ATTACHMENT A

KENWOOD COMMUNITY & SENIOR CENTER ATTACHEMENT A

ADDENDUM #1 – REVISED DRAWINGS

S3.11
Beaty Palmer Architects, Inc. all rights reserved.
no part of this document may be reproduced or utilized in any form
without prior written authorization of beaty palmer architects, inc.
BEATY PALMER ARCHITECTS

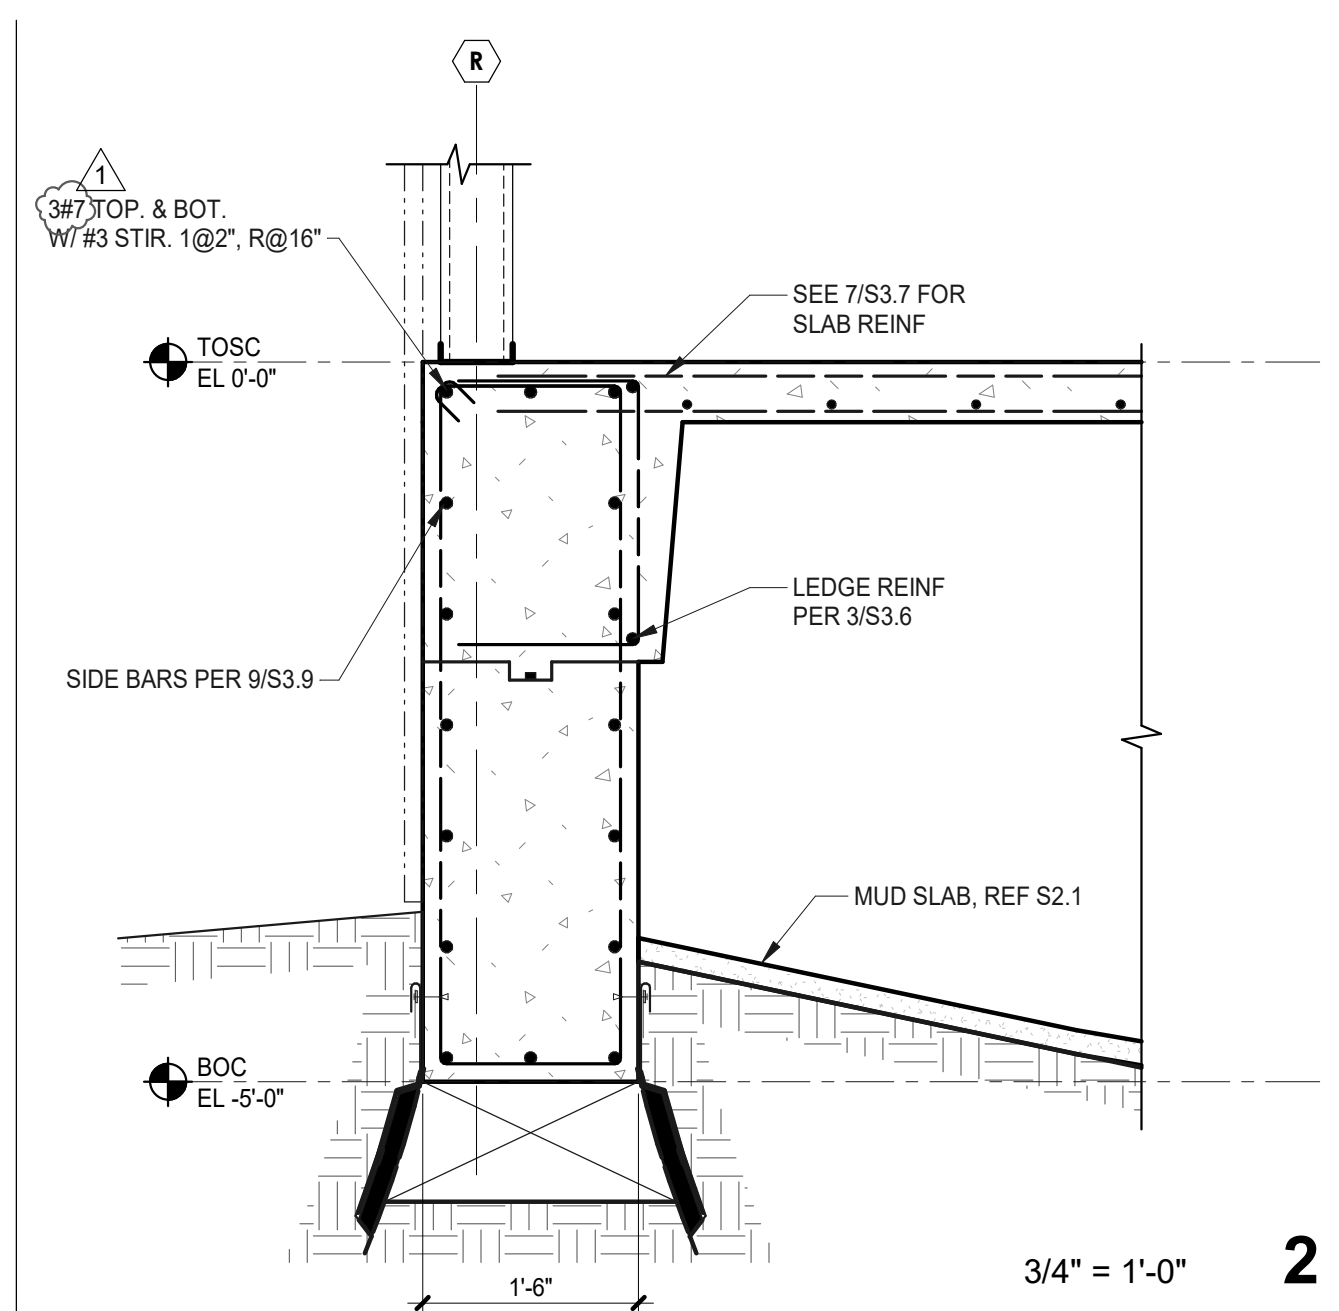
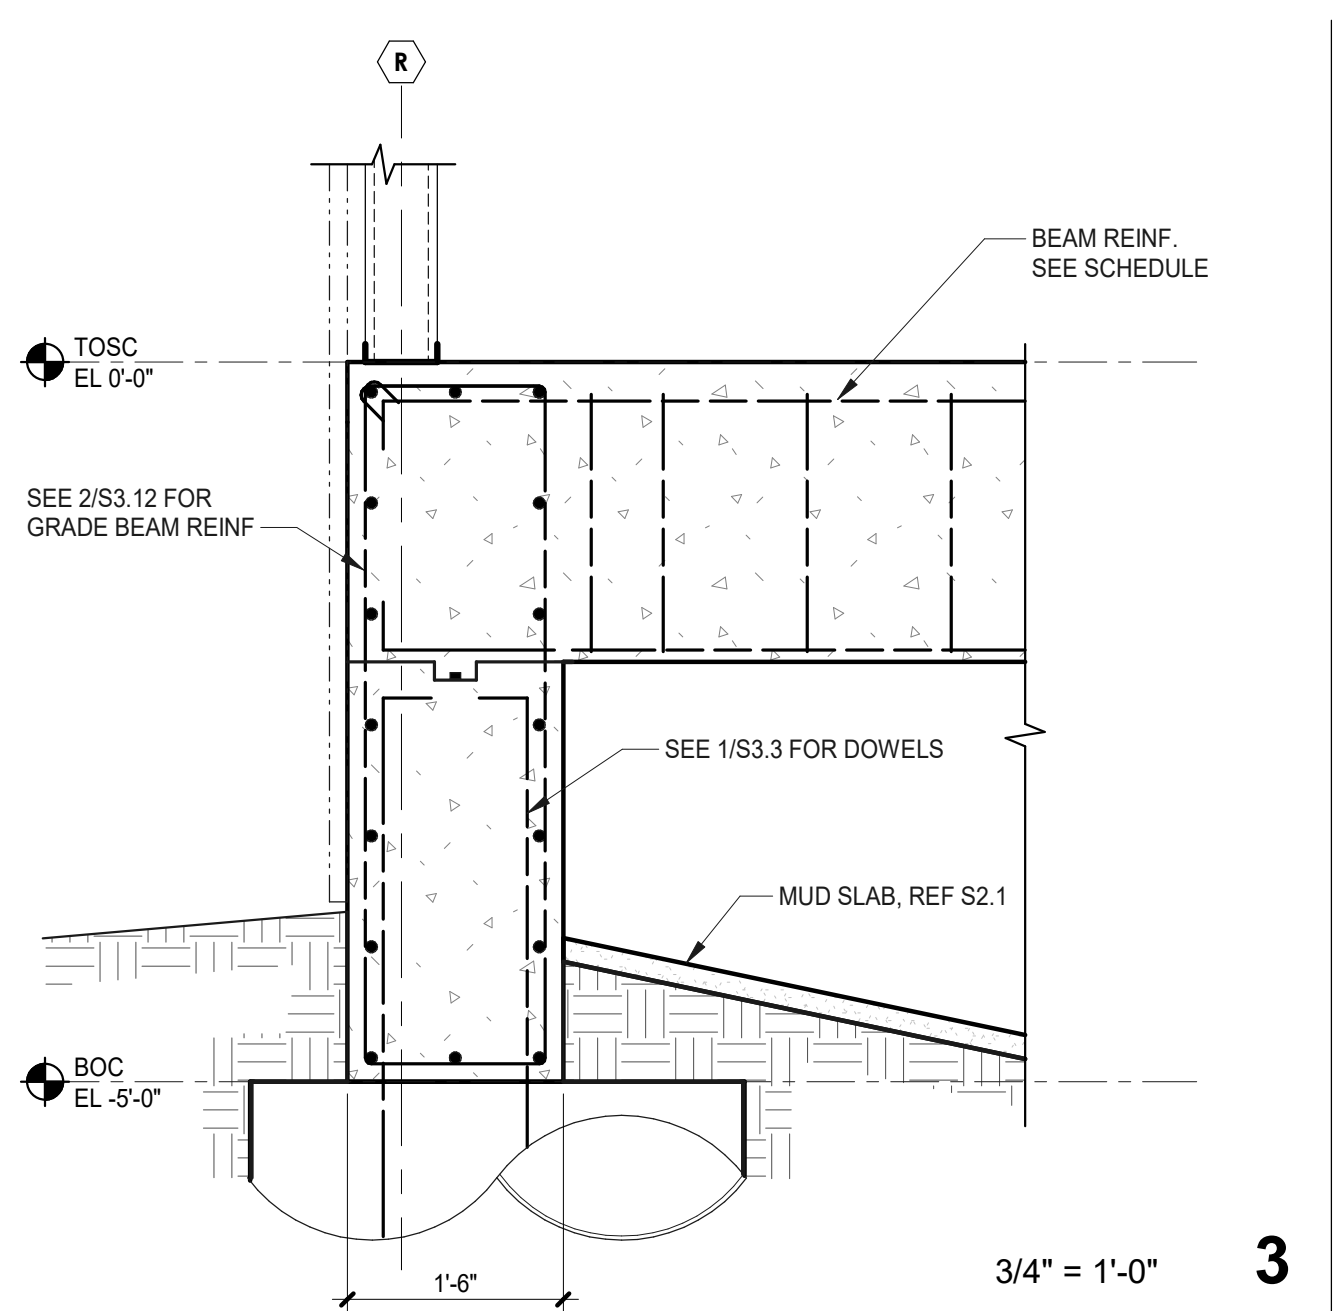
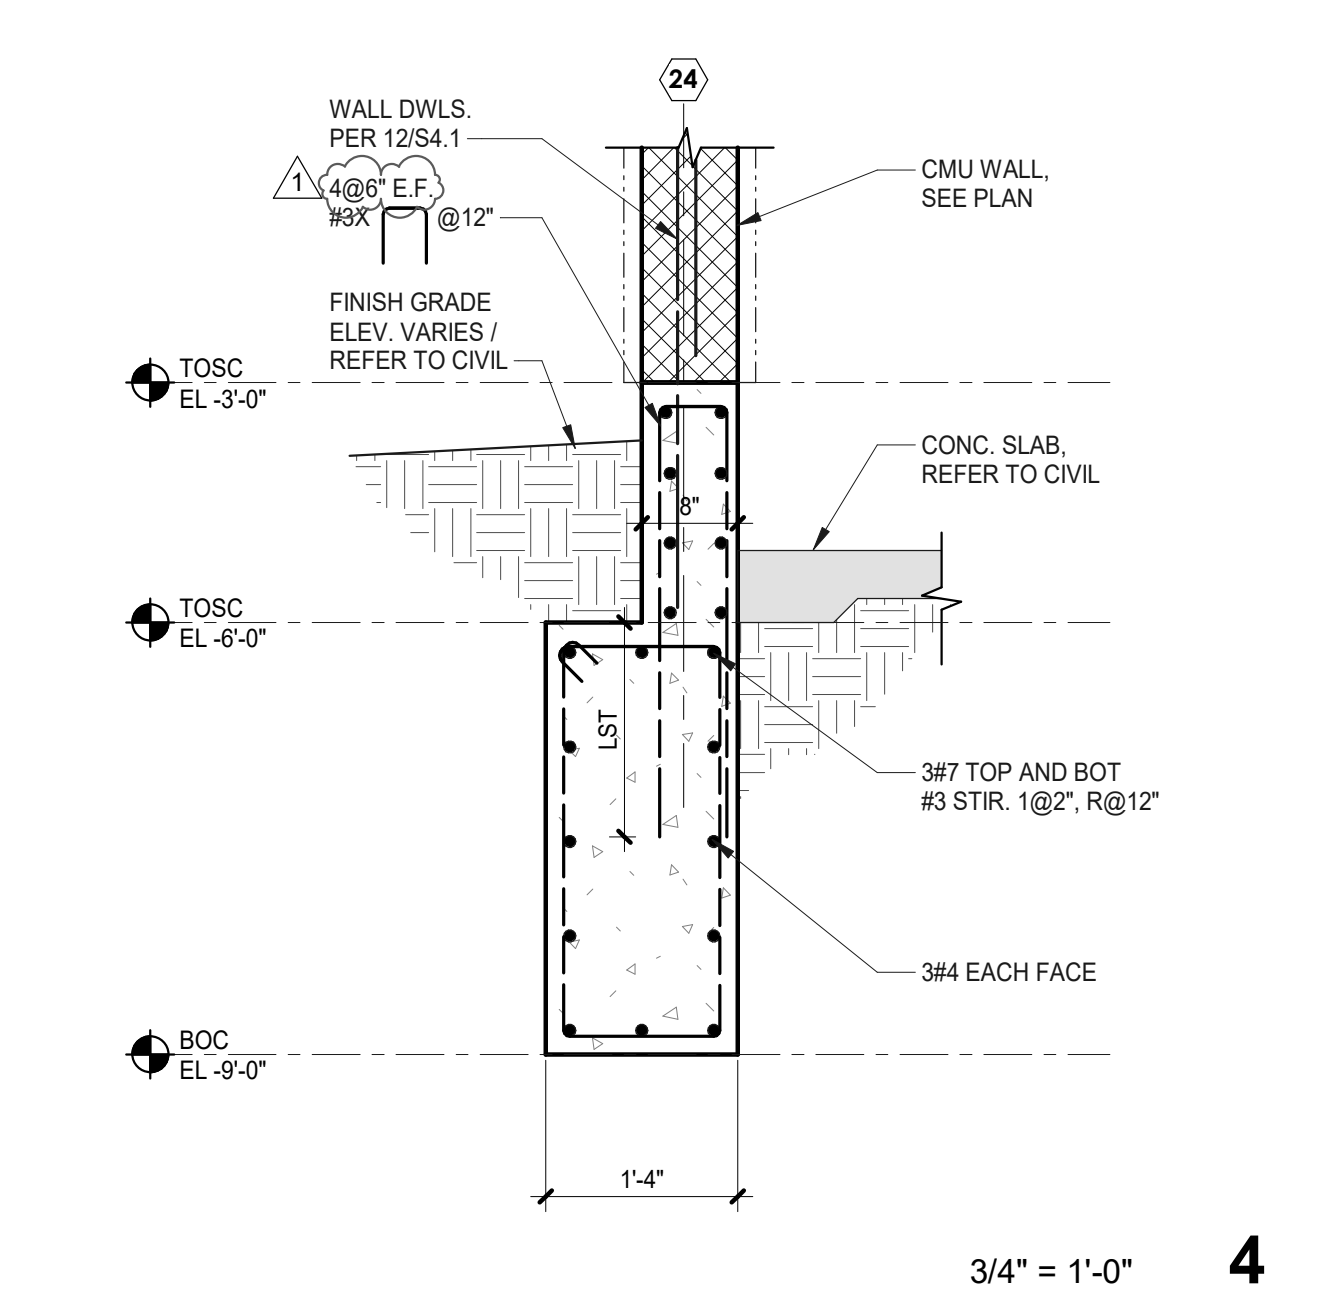
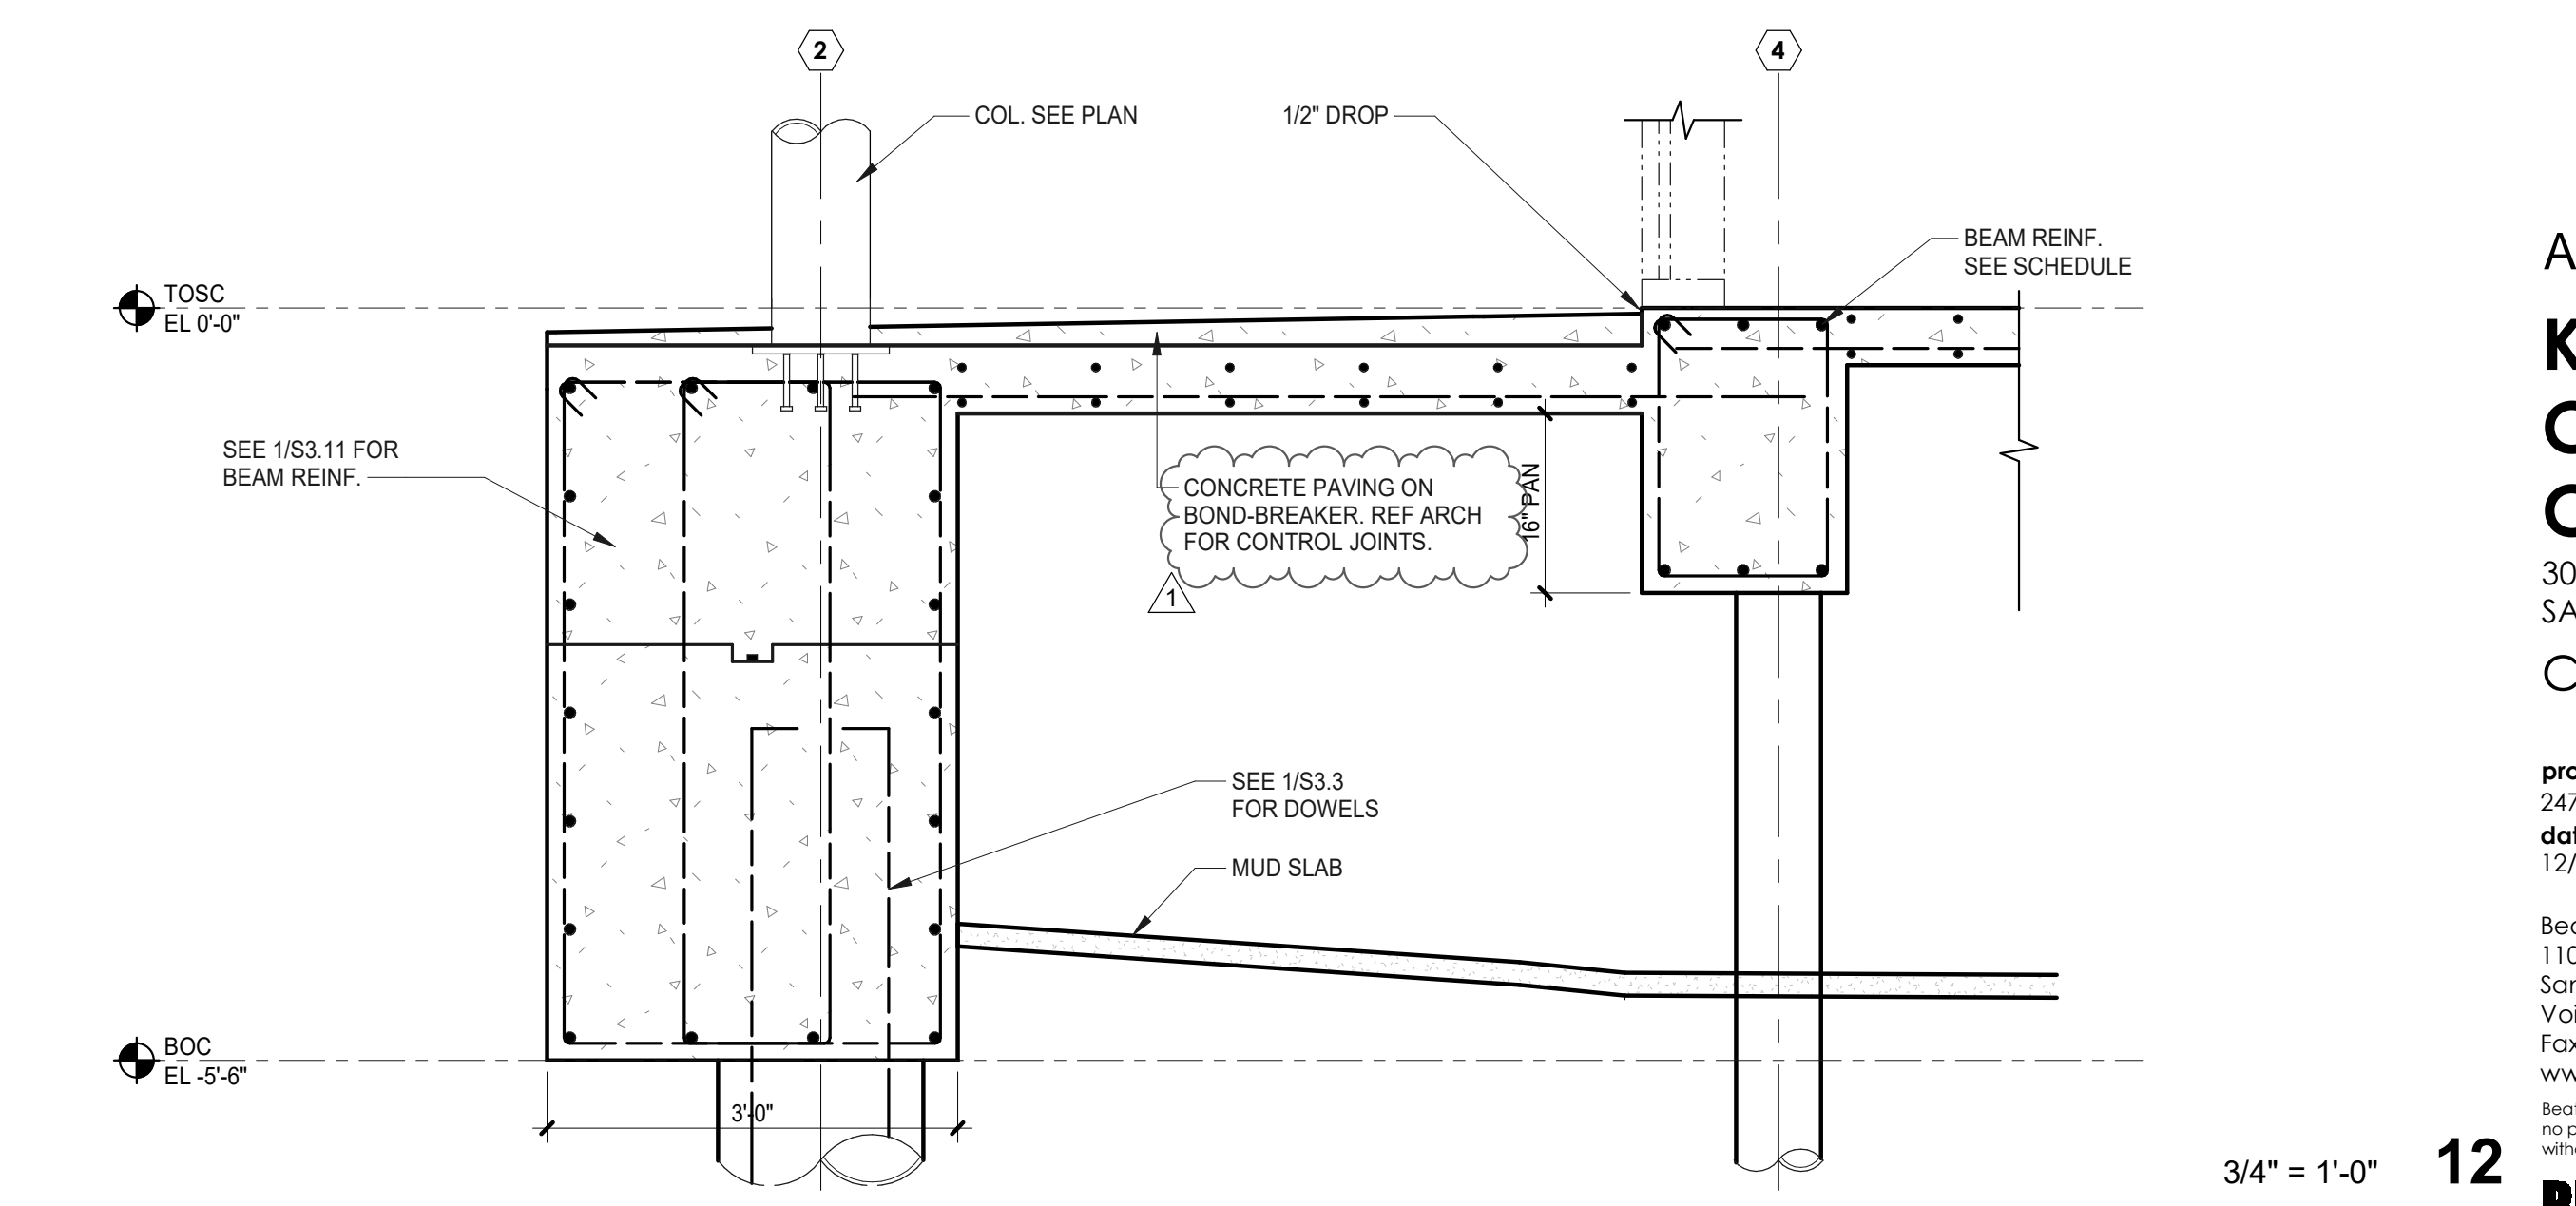
The roughened concrete has been replaced with a bond breaker to improve crack control, refer to attached revised sheet S3.11 & S3.12
